## PRODUCT CHANGE NOTIFICATION

Date: 13, 08, 2018  
PCN: PCN LEDIL NR146

Subject: PCN NR146 - Change of Florentina holder design

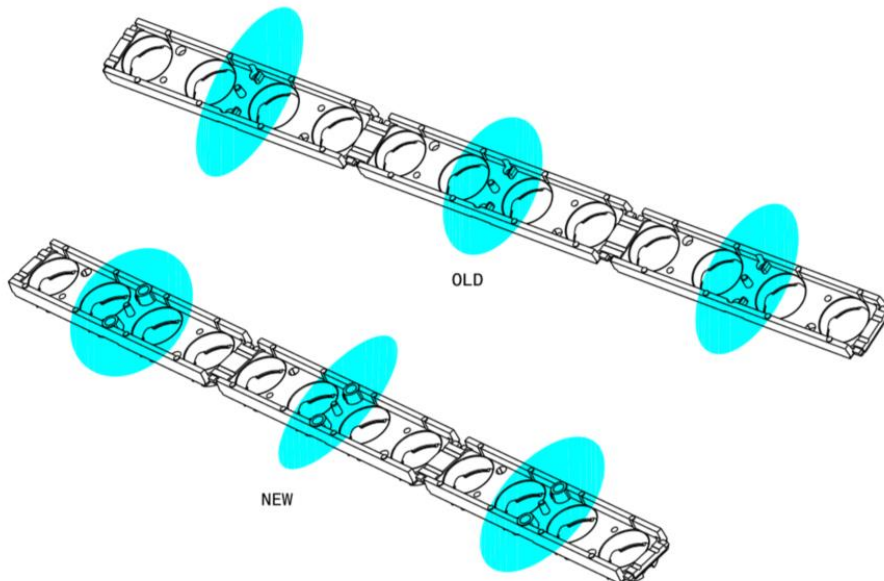
Description: As part of our continuous improvement process regarding the quality of our products LEDiL has changed C14445\_FLORENTINA-HLD design to improve screw fastening to PCB/heatsink. All external dimensions remain the same. [New mechanical drawing](#)

Changes:
